GENERAL APPLICATION

Explanation of Request: Variance, Design + Site Plan Review

STIRLING LOGISTICS CENTER

Final Technical Assistance Review
 Prepared for Cadence Partners LLC
 2910 Stirling Road
 Hollywood, Florida, 33020

ALTA/NSPS LAND TITLE SURVEY

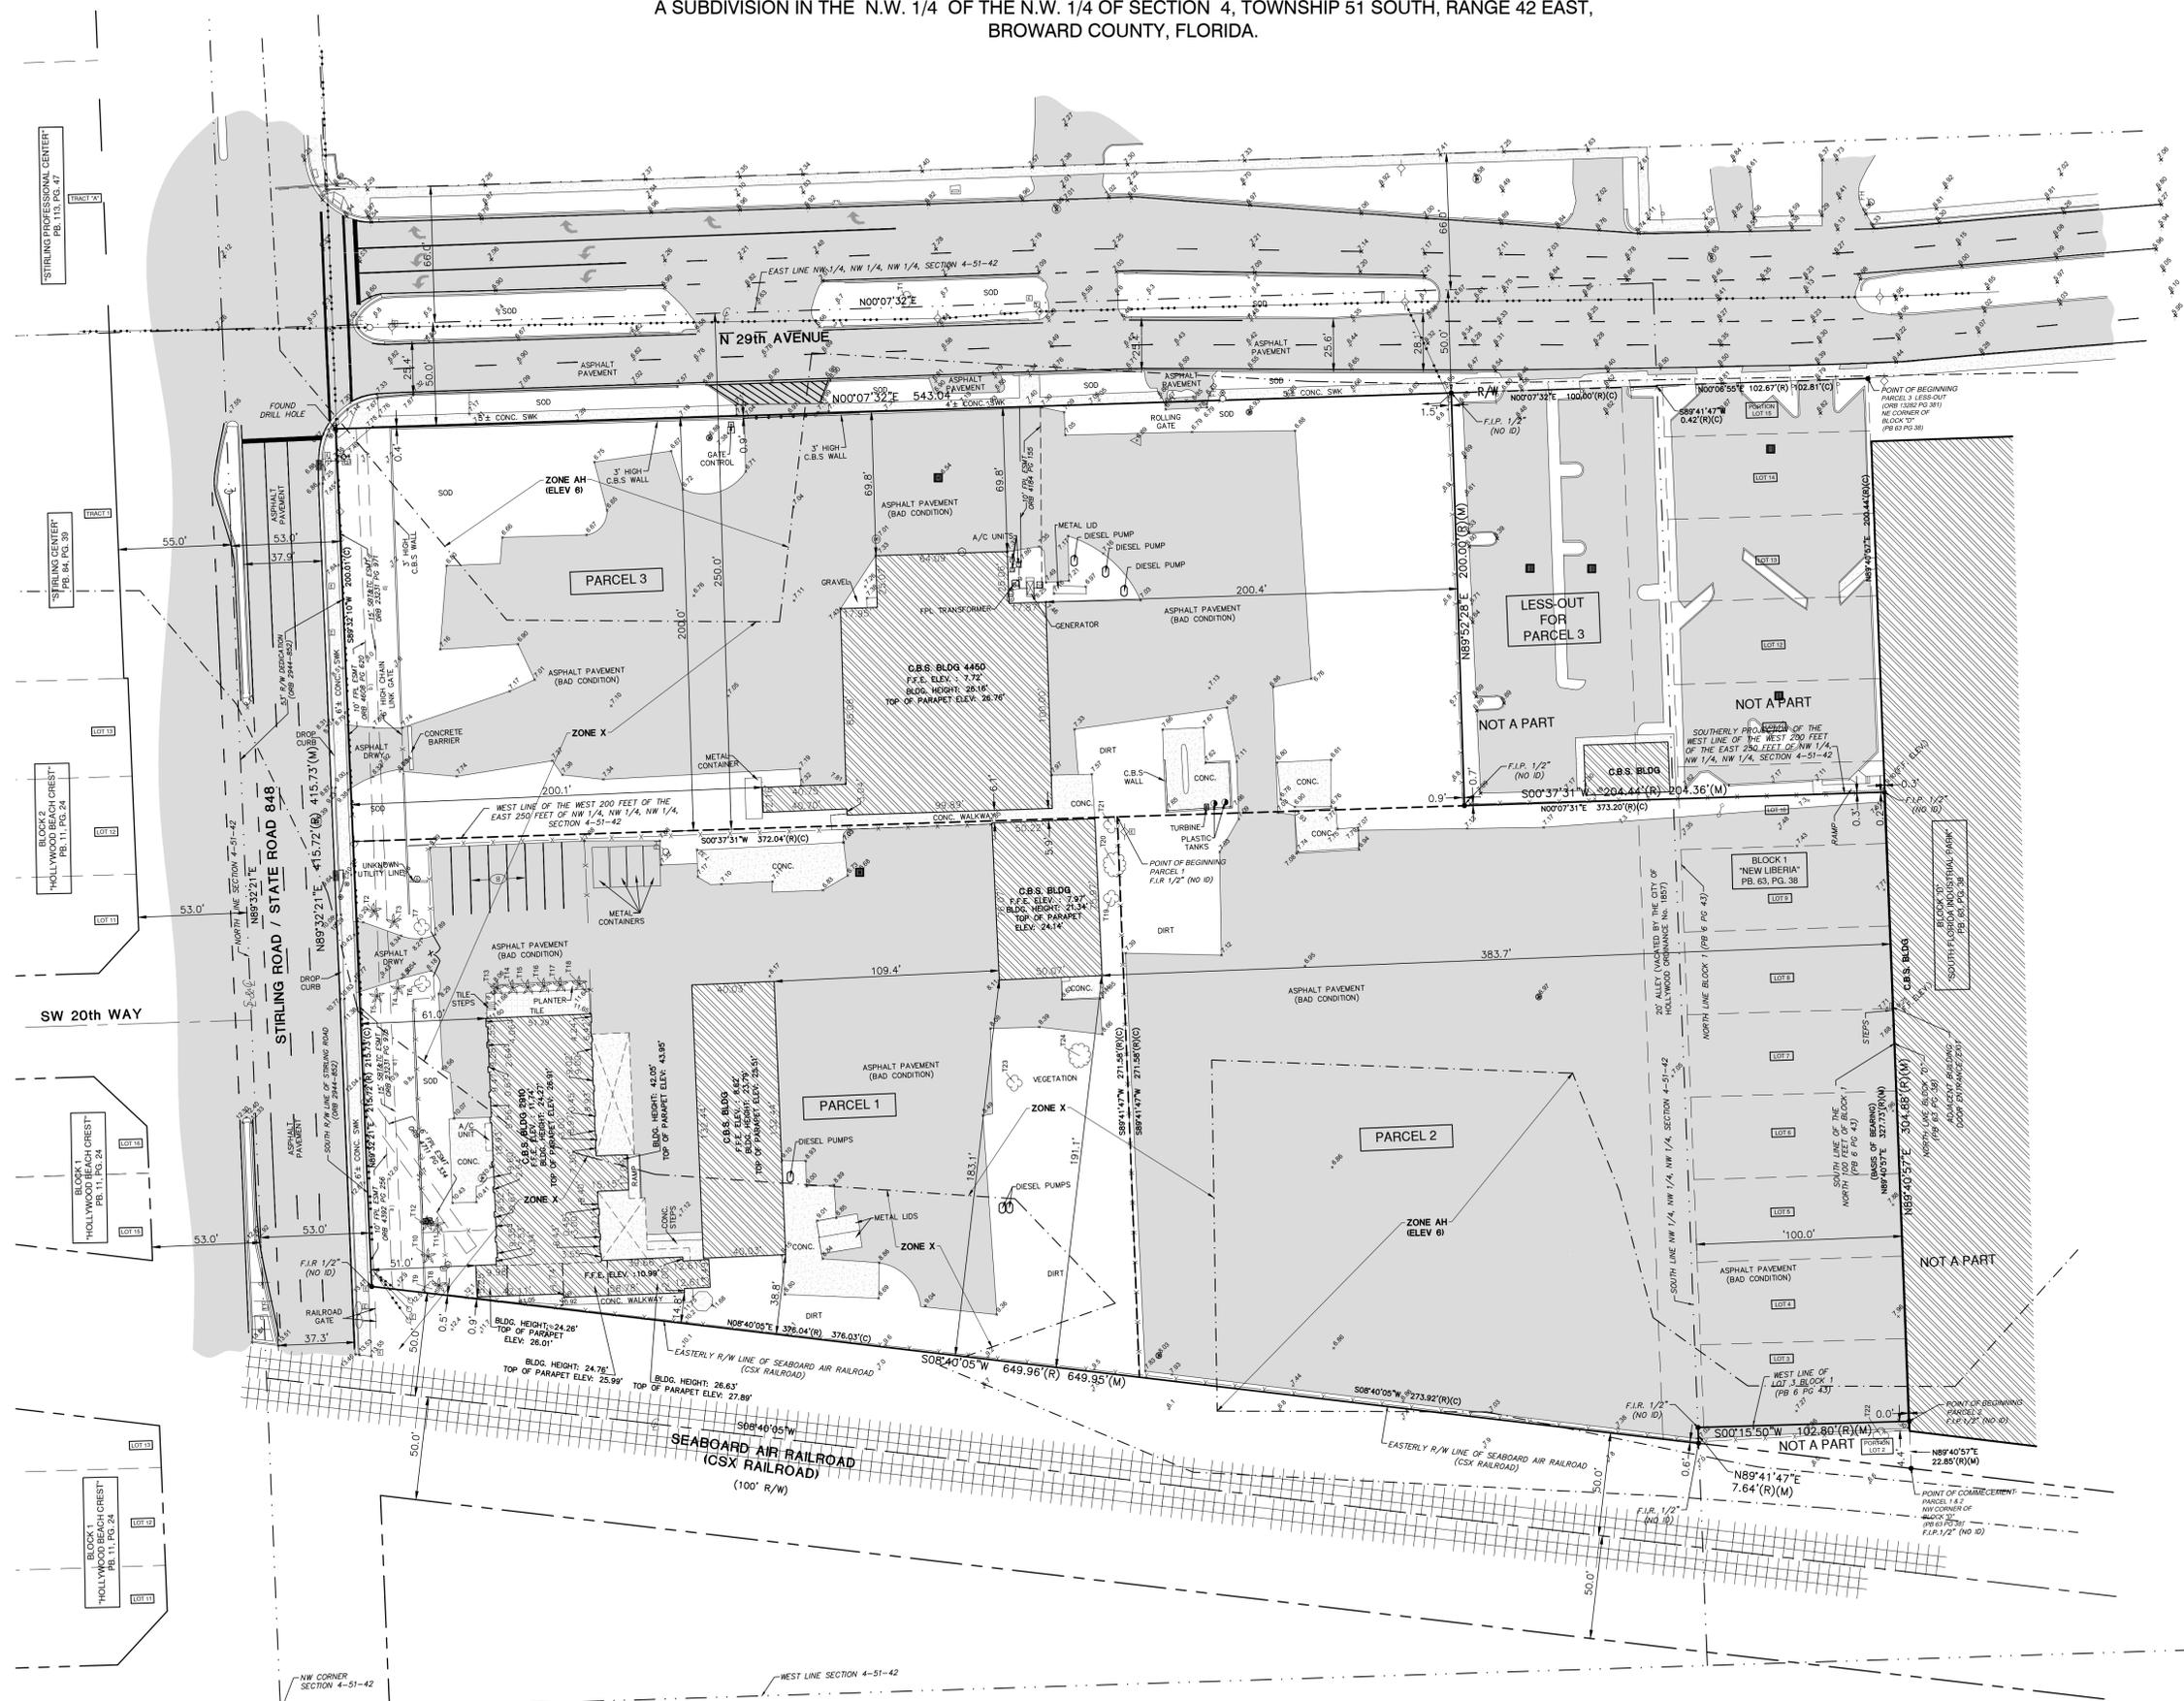
1. Survey – The incorrect FEMA Flood Zone is indicated. The area designated Flood Zone “AH” with Elev. 5 should be designated Zone X. Please refer to the FEMA Map Service Center snapshot below. Revise note on Sheet 1 / 2 of the Alta Survey

TITLE: MASTER SITE PLAN AND SITE STATISTICS
 DRAWING NO: A-0.1

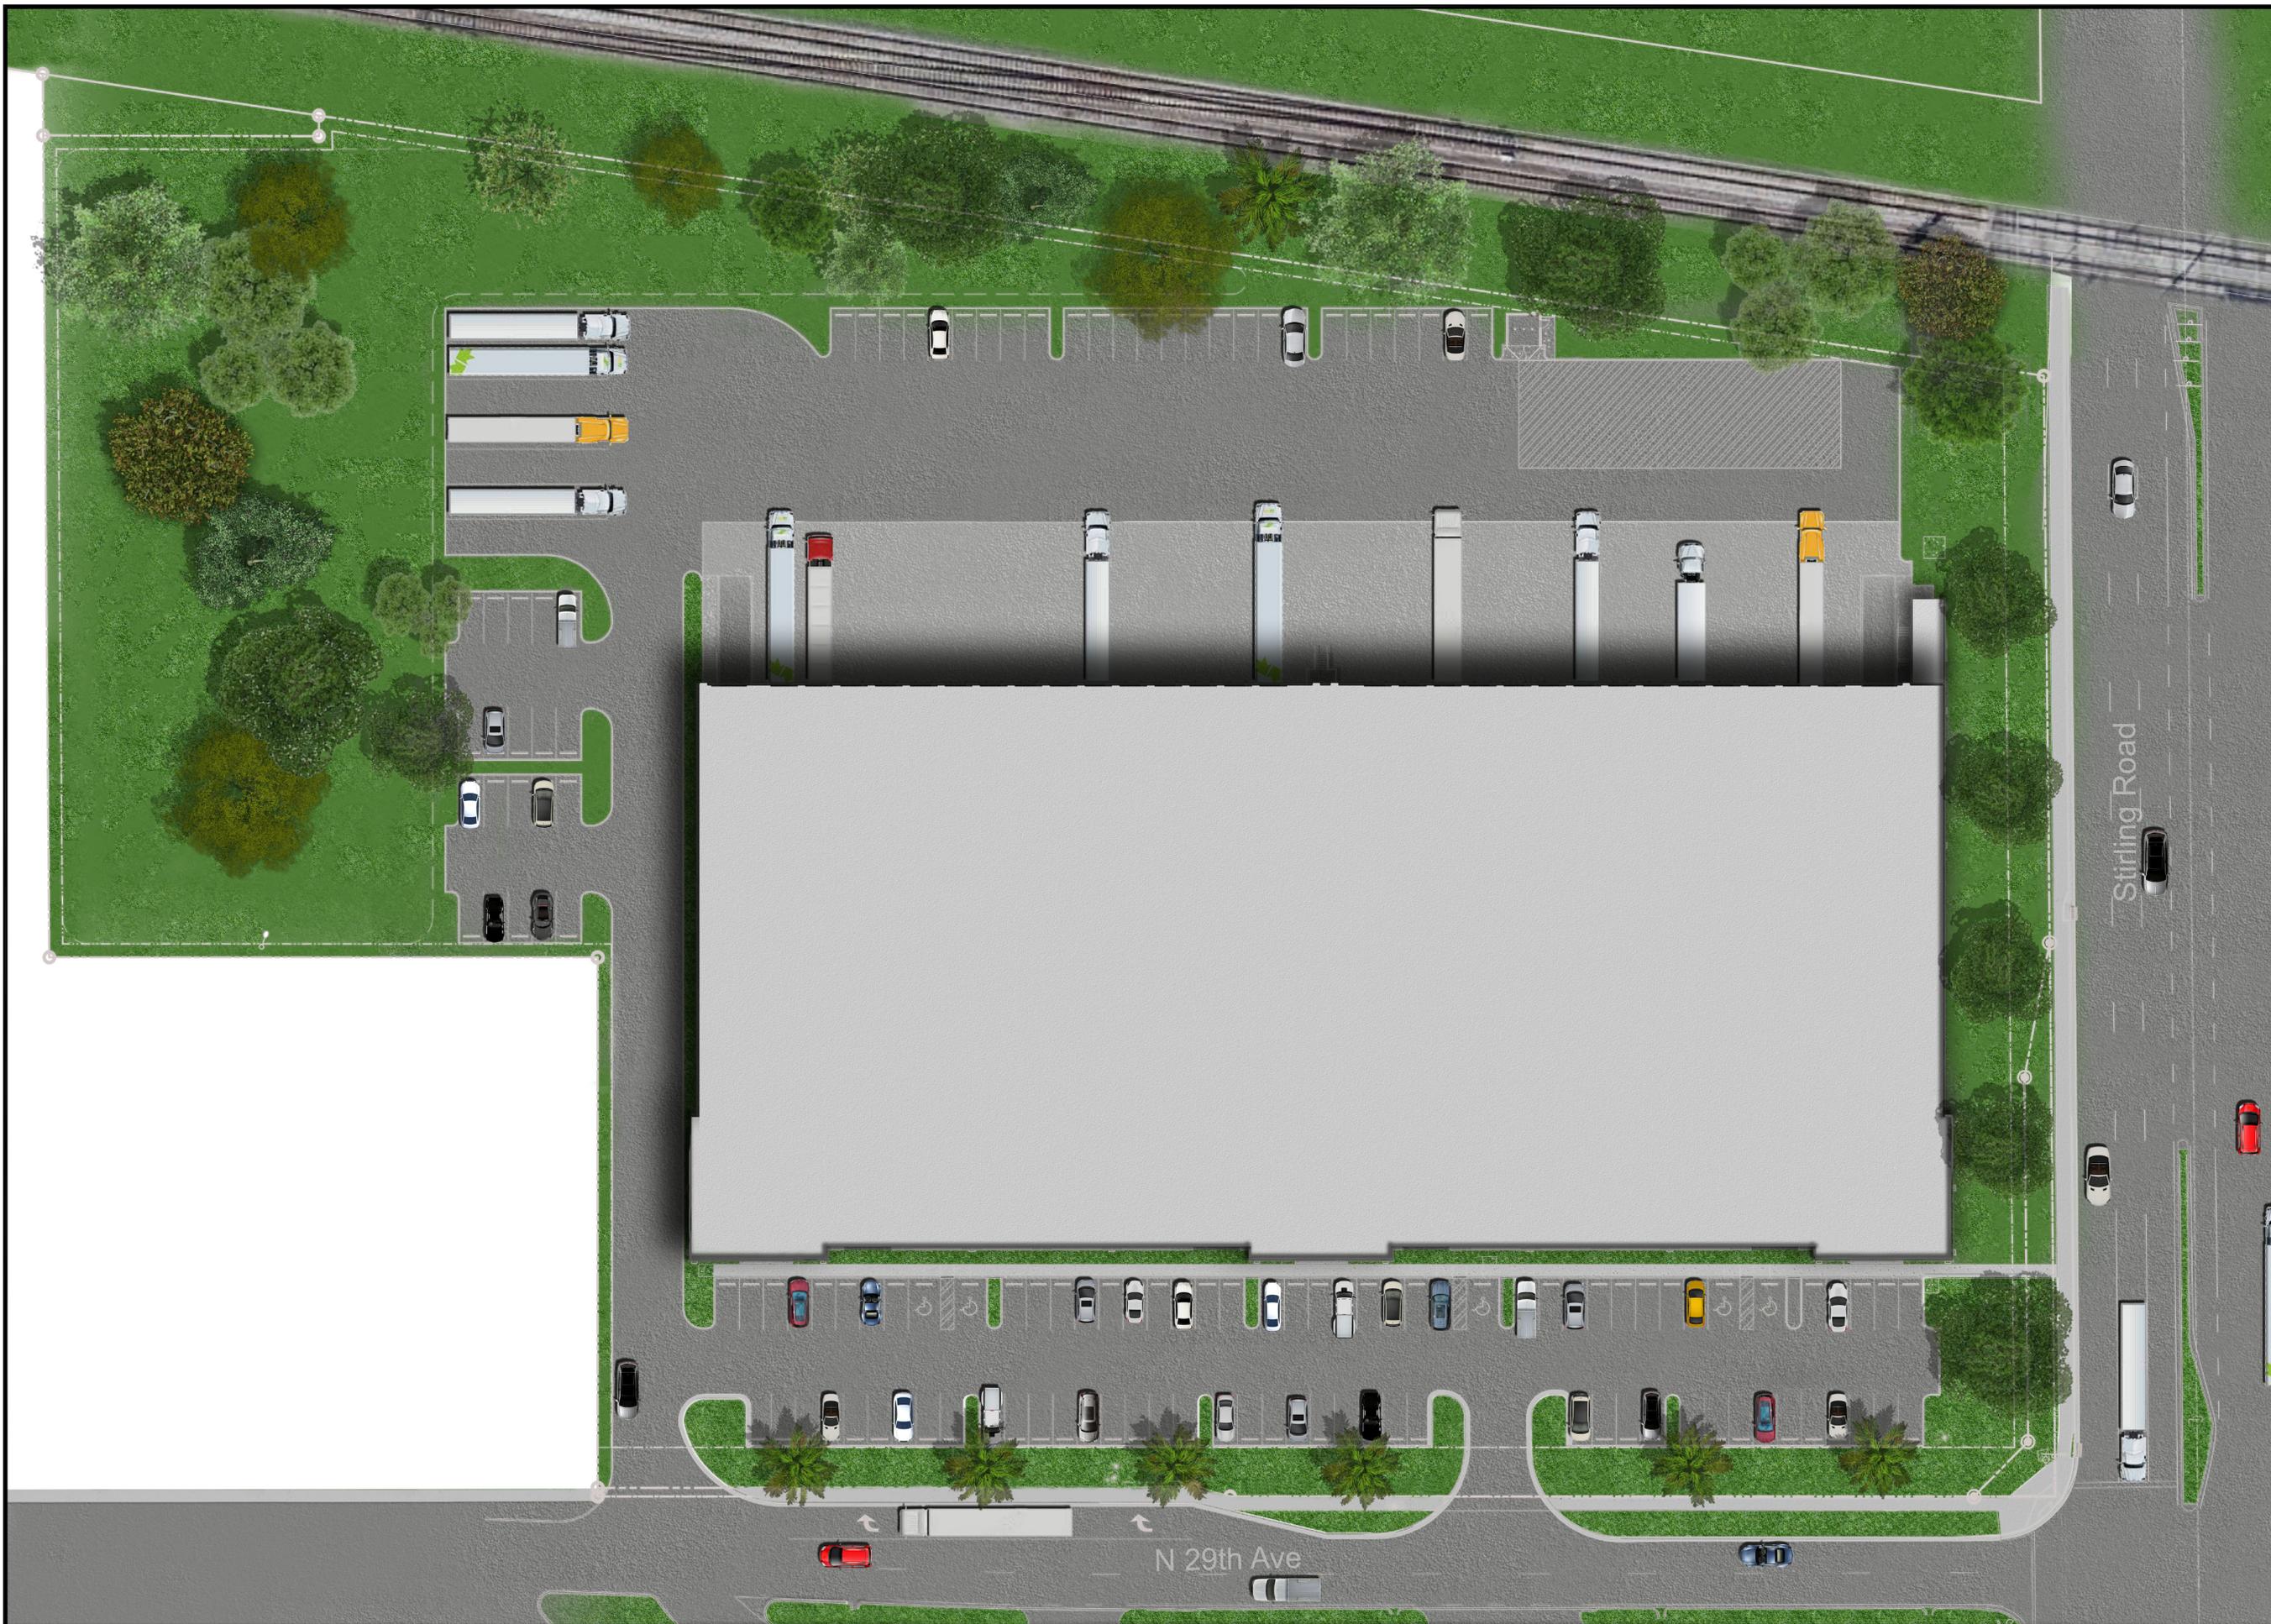
- 9) Sheet A-0.1, call out and leader for the dumpster is pointing to the parking area.
****Comment addressed. ****
 - 10)The dumpster is encroaching beyond the new property line.

SHEET No.
 PD-1

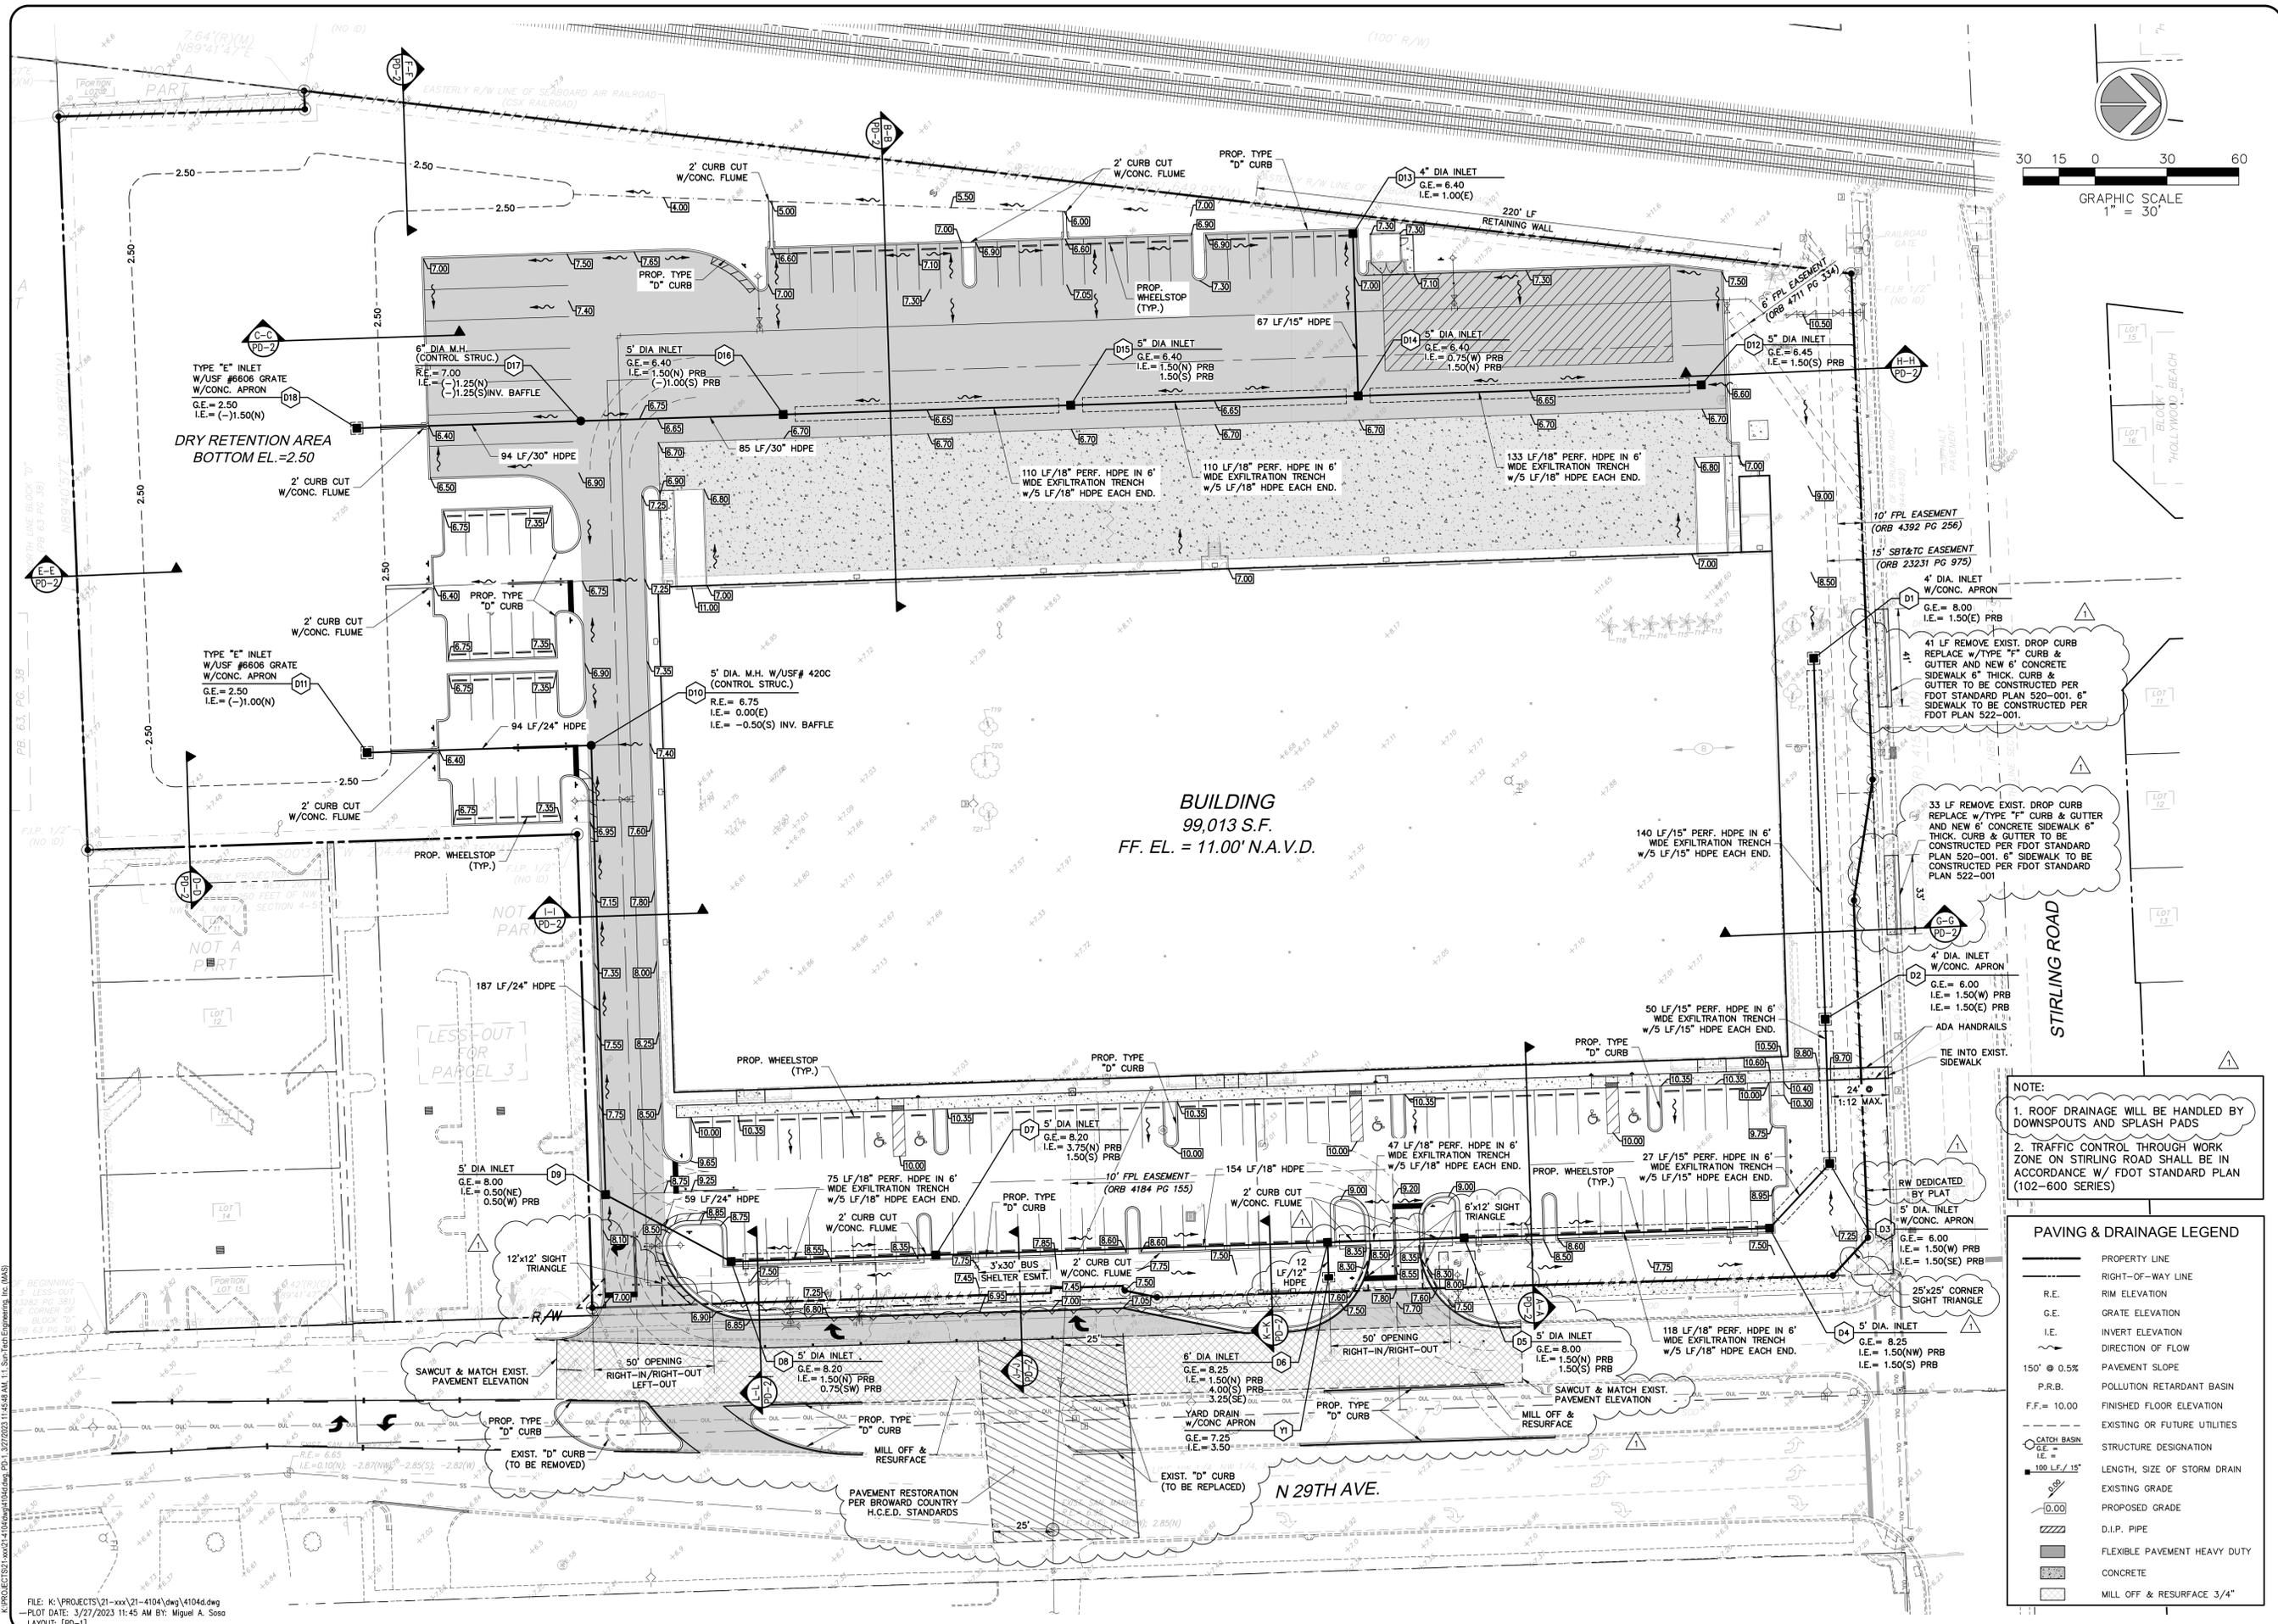
Note has been added above the legend on sheet PD1 indicating that roof drainage will be handled by downspouts and splash pads, which will sheet flow into the storm water drainage structures.
